CITY OF FORT LAUDERDALE

CASE COMMENT REPORT

CASE NO. UDP-S25025

CASE	UDP-S25025
PROJECT NAME	111 W Davie Blvd – Self Storage Facility
APPLICATION TYPE	Site Plan Level II
APPROVAL LEVEL	DRC
REQUEST	50,112 Square Foot Self Storage Facility
APPLICANT	Segall Development LLC.
AGENT	Sara Thompson, Miskel, Backman
PROPERTY ADDRESS	111 and 113 W. Davie Boulevard
ABBREVIATED LEGAL DESCRIPTION	Placidena Unit B 5-8 Lot 9 less S 15 for ST BLK 8
ZONING DISTRICT	South Regional Activity Center – South Andrews west (SRAC-Saw) District
LAND USE	South Regional Activity Center
COMMISSION DISTRICT	4 – Ben Sorensen
NEIGHBORHOOD ASSOCIATION	Tarpon River Civic Association
SUBMITTED	June 20, 2025
COMPLETENESS ISSUED	June 25, 2025
EXPIRATION	December 22, 2025 (180 Days)
WAIVER	N/A
CASE PLANNER	Tyler Laforme, AICP Urban Planner III

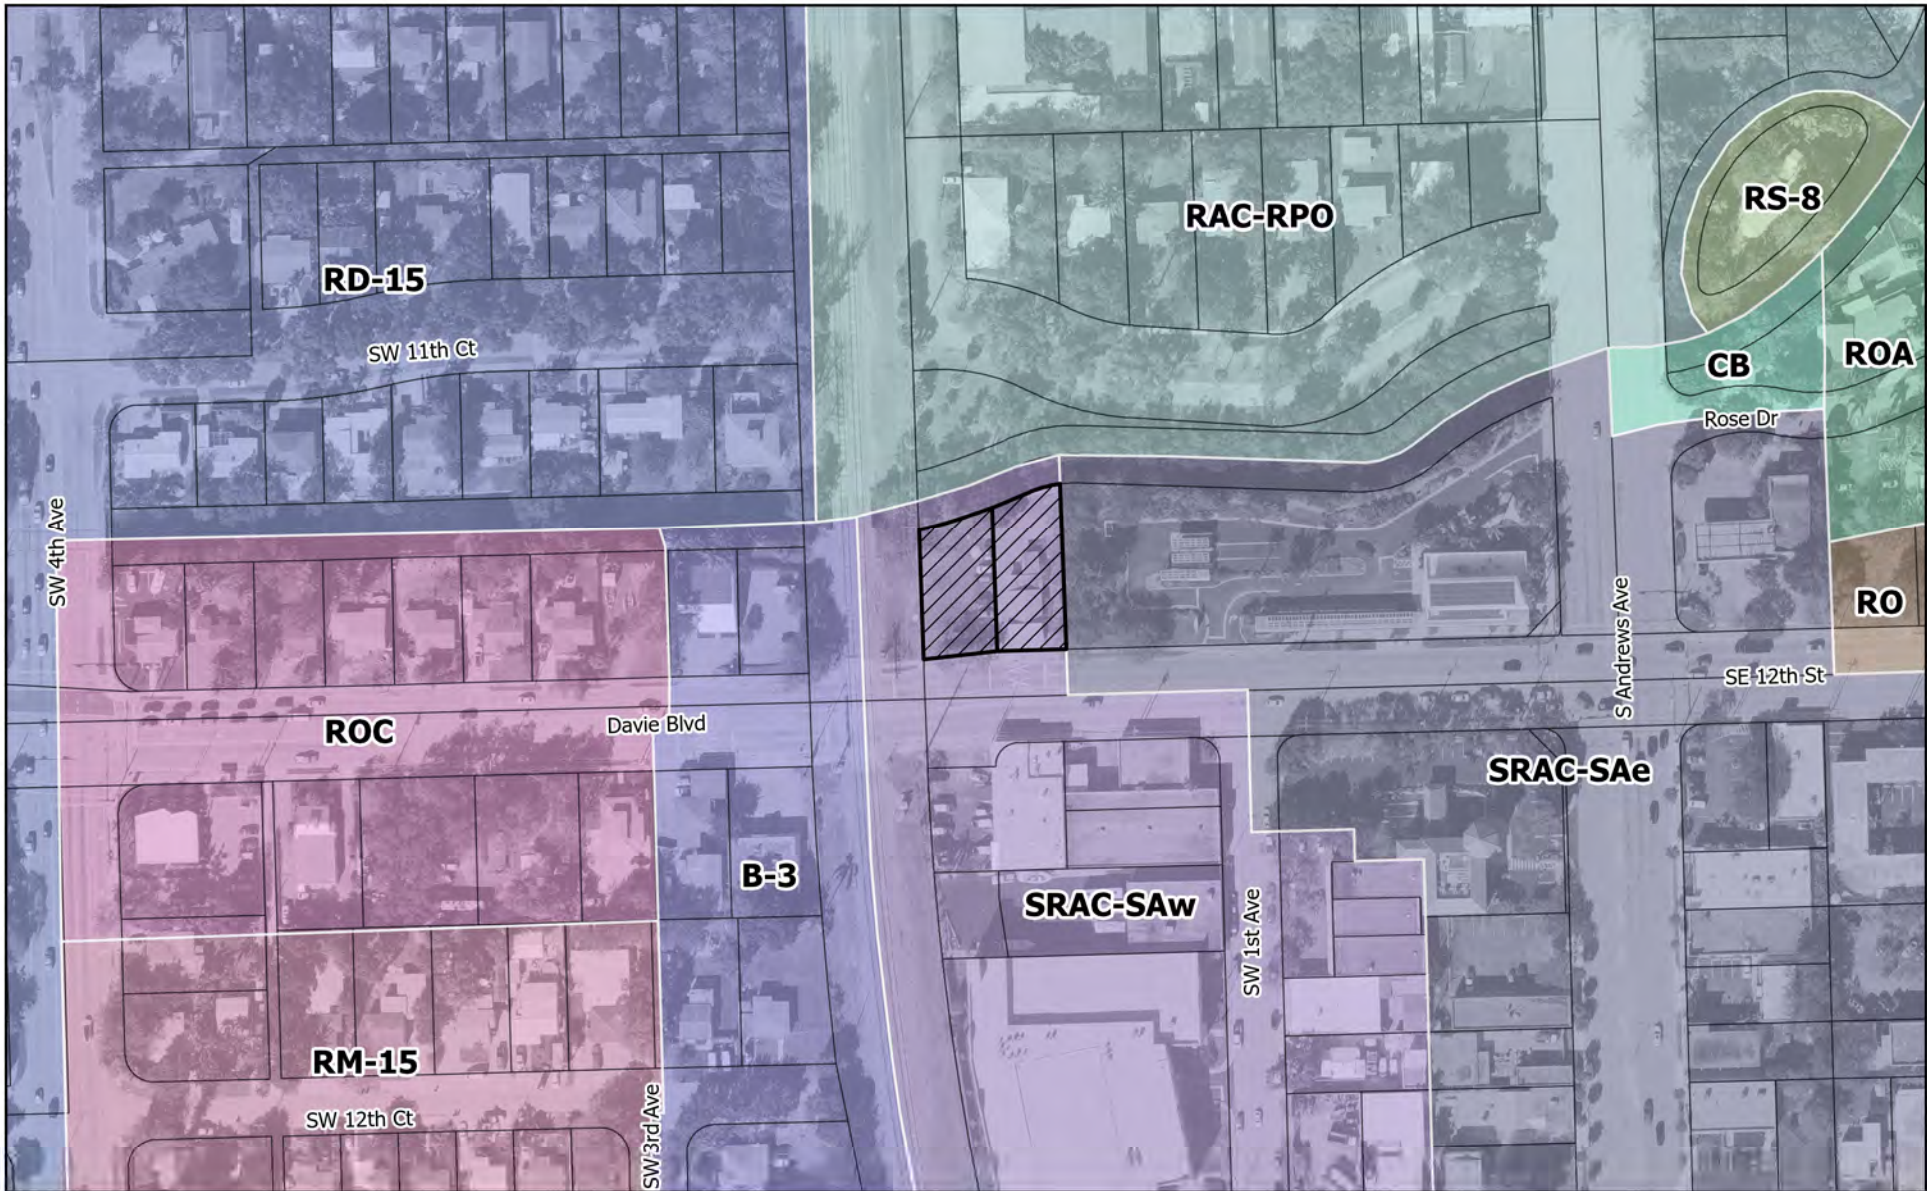
- e. B-14 & B-16) The current design of the building has a multitude of design elements such as horizontal/vertical scored stucco, faux balconies, visual layering of floor levels, and six different paint colors. While the masterplan strives for a creative façade composition, the complexity of materials on this façade seems overwhelming and does not visually break up the boxy massing of the project. Provide design elements and materials focused on the main corners of the building, with emphasis on the first two levels and the main entrance to the building to help reduce the visual massiveness of the project. See examples below:
